Model: K-P1, A-C2, J-P1		Date: 03-Jul-01	No.: RB003008
Subject: Slow Printing from Macintosh		Prepared by: K. Misugi	
From: Technical Services Dept., GTS Division			
Classification:	<input checked="" type="checkbox"/> Troubleshooting <input type="checkbox"/> Part information <input type="checkbox"/> Action required <input type="checkbox"/> Mechanical <input type="checkbox"/> Electrical <input type="checkbox"/> Service manual revision <input type="checkbox"/> Paper path <input type="checkbox"/> Transmit/receive <input type="checkbox"/> Retrofit information <input type="checkbox"/> Other (      )

Model: General (GW Models)		Date: 20-Dec-01	No.: RGene010
Subject: Series Print Mode		Prepared by: K. Misugi	
From: Technical Services Dept., GTS Division			
Classification:	<input checked="" type="checkbox"/> Troubleshooting <input type="checkbox"/> Part information <input type="checkbox"/> Action required <input type="checkbox"/> Mechanical <input type="checkbox"/> Electrical <input type="checkbox"/> Service manual revision <input type="checkbox"/> Paper path <input type="checkbox"/> Transmit/receive <input type="checkbox"/> Retrofit information <input type="checkbox"/> Other (      )

Mo

### BCU Board Installation Procedure:

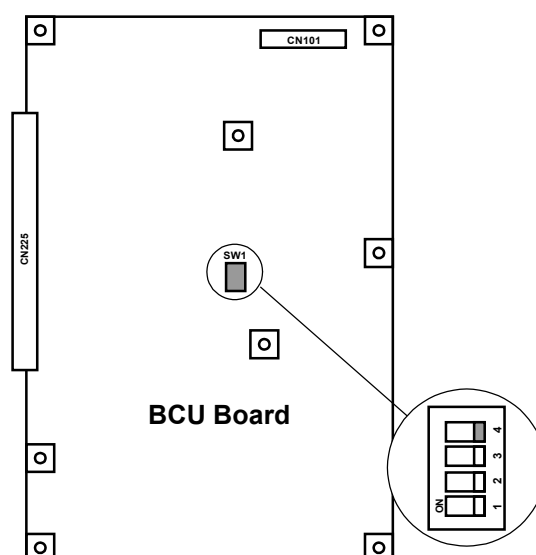
A fusing clutch has been added to the G060 series (Model J-P1b). To regulate the new clutch, a DIP Switch has been added to the BCU board. The new board can be used in both new machines (with the fusing clutch) and older machines (without the clutch). However the switch setting is different as shown below.

DIP SW No.	OFF	ON
4	Fusing clutch is <b>not</b> installed.	Fusing clutch <b>is</b> installed.
1 to 3	Factory Use Only: Keep these switches OFF.

1. Make sure all DIP switches on the new BCU board are switched OFF.
2. If the board already installed in the machine has no DIP SW, simply install the new board as is, i.e. with the DIP SW switched OFF.
3. However if the board already installed has a DIP SW, set the SW on the new board to match the setting on the old board before installation.
4. After installing the BCU board, make sure the machine is able to print out the configuration page normally.

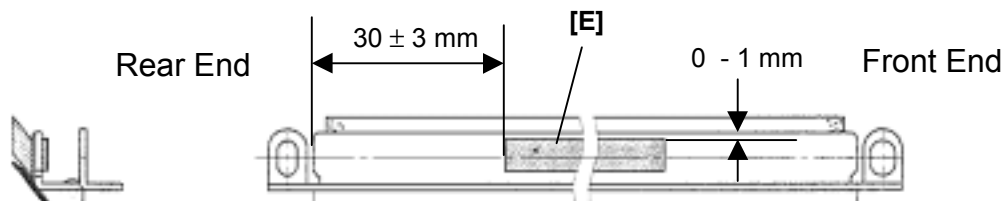
**NOTE:** If the fibers are stroked in the opposite direction, this may lead to vertical white lines on the outputs.

8. Clean the cushion attachment areas on the surfaces of the metal plates with alcohol.
9. Mark a line  $30 \pm 3\text{mm}$  from the rear edge of the brush.
10. Place the brush onto a few sheets of clean paper and attach the cushion [E] onto the metal plate of each brush, aligning the edge of the cushion with the edge of the brush.

**NOTE:** When attaching the cushions, be careful not to push down on the brush too strongly. This is because doing so can damage the Mylar and/or flatten out the brush fibers, which can prevent contact between the fibers and transfer belt and lead to vertical white lines.

## 2. Wiring the cable of the heating roller fusing lamp

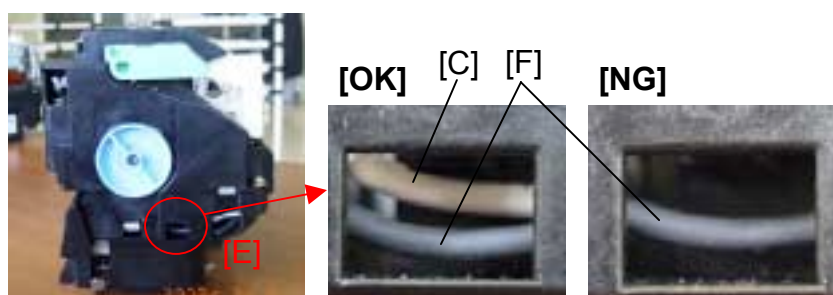
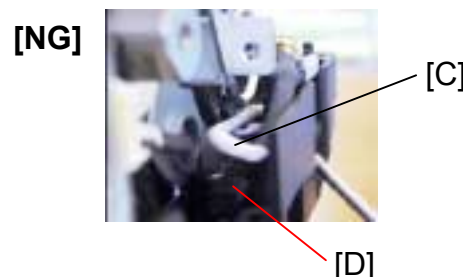
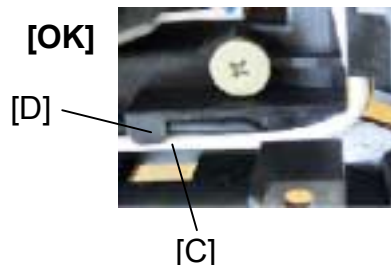
When securing the white cable [C] of the heating roller fusing lamp (front side), make sure to lead it underneath the projection [D] as shown.

1. This positioning is essential. If the cable is above the projection, the C-ring of the heating roller may contact the cable and damage the protective sleeve. In the worst case, this could lead to an electrical short circuit.
2. If the white cable has been properly led, you will be able to see both it [C] and the gray cable [F] through the window [E] in the fusing unit cover.

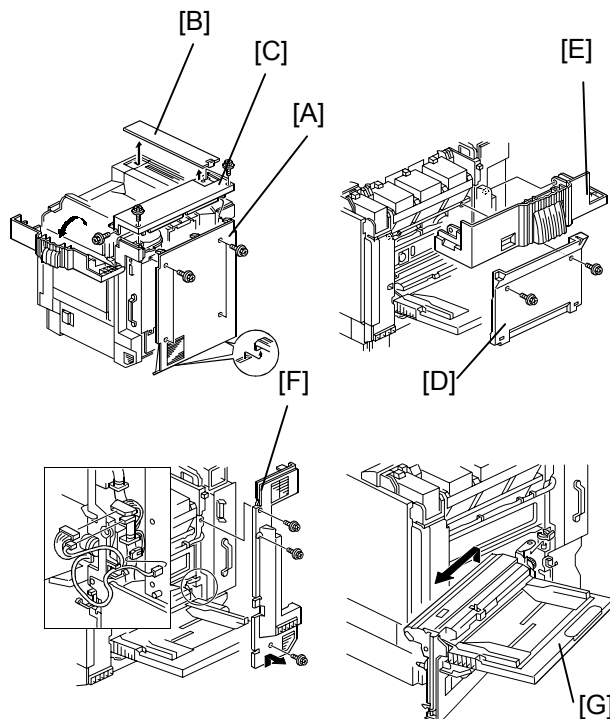
The electrical resistance of the Sheet (#G0602632) attached to the Guide Plate – Middle Registration is out of specification in some machines from July to September '01 production. This may cause the static electricity generated during a multi-print run to charge the Sheet, leading to a jam at the registration area (occasionally a Z-jam).

**NOTE:** The Sheet cannot be replaced individually in the field, since it is fixed to another sheet of Mylar. Therefore as mentioned in MB #MG060003, the “Guide Plate – Middle Registration” (#G0602613) has been newly registered as an assembly of the previous Guide Plate, Sheet, and Guide.

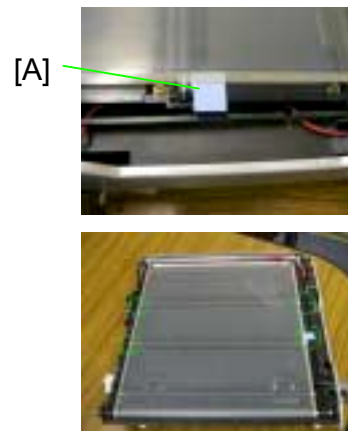
The following changes have been made to increase the durability of the packaged Transfer Unit (service part) against rough handling during transport.

If the Transport Unit experiences rough handling during shipping, the unit components can become damaged, e.g. back-up rollers detached, plastic components broken.

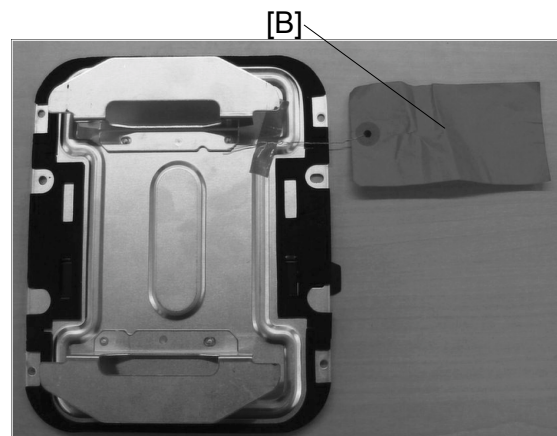
**Caution:** If the sponge is not removed, the polygon mirror motor can be damaged and/or the printer may not function correctly.

1. Open the upper cover [A] (4 screws).

2. Remove the red tag [B] (tape).

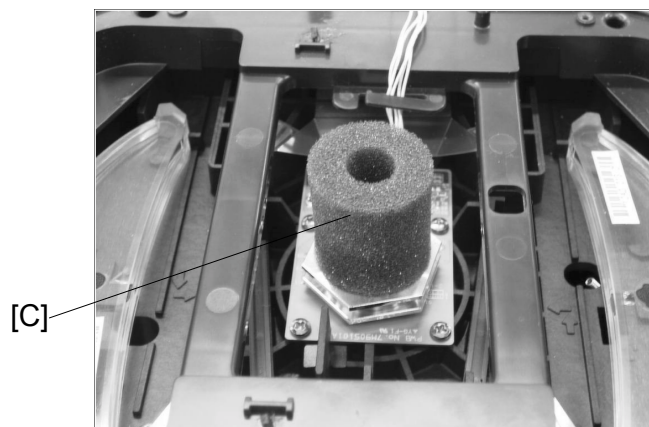
3. Remove the sponge [C].

**Note 1:** Be sure not to touch any of the mirror or lens surfaces.

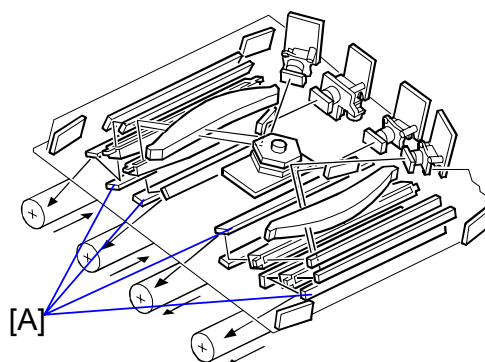
The third mirror(s) [A], which direct the laser to the OPC, were out of position. Rough handling of the service part during transportation might cause this problem.

As shown in the pictures, the spring plate [B] positions the mirror. The mirror may become the out of position, changing the angle with the OPC drum.

If color(s) is (are) missing on the output, remove the laser optics housing unit and lower cover (10 screws), and reposition the mirror(s) for the missing color(s) once the spring plate is removed.

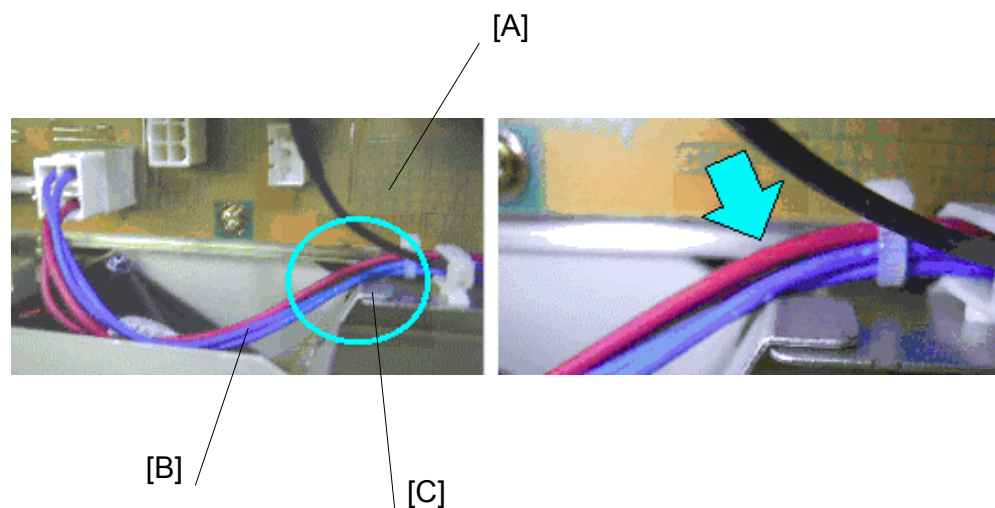
Power is not supplied when the main switch is turned ON after replacing the PSU [A], Harness - AC Switch [B] or Bracket – PSU Fan [C].
